BMW Motorrad USA

Service Information Bulletin

****Notice of Recall 15V-537****

Subject: Engine idle unstable

► Tightening clamp at throttle body

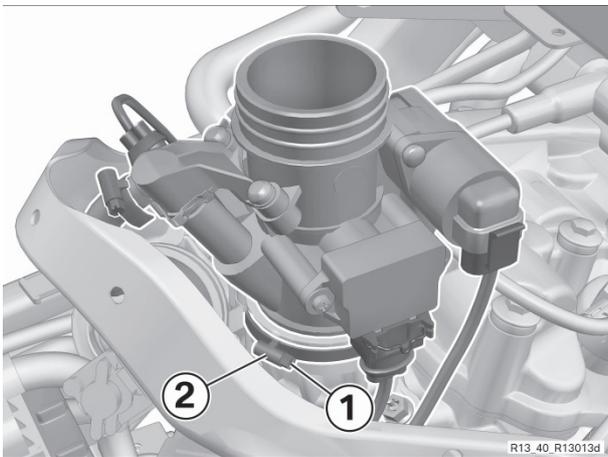
Tightening the screw clamp of the throttle body with excessive force or unsuitable tools.

Impaired engine running due to deformed intake stub.

- Use only a plain slotted screwdriver to tighten the screw clamp, without using additional tools.
- Do not use torque-amplifying tools such as an open-end spanner or a reversible ratchet for extra leverage.

- Use only a plain slotted screwdriver.

- Slacken screw **(1)**.
- Position clamp **(2)**.
- Tighten screw **(1)**.
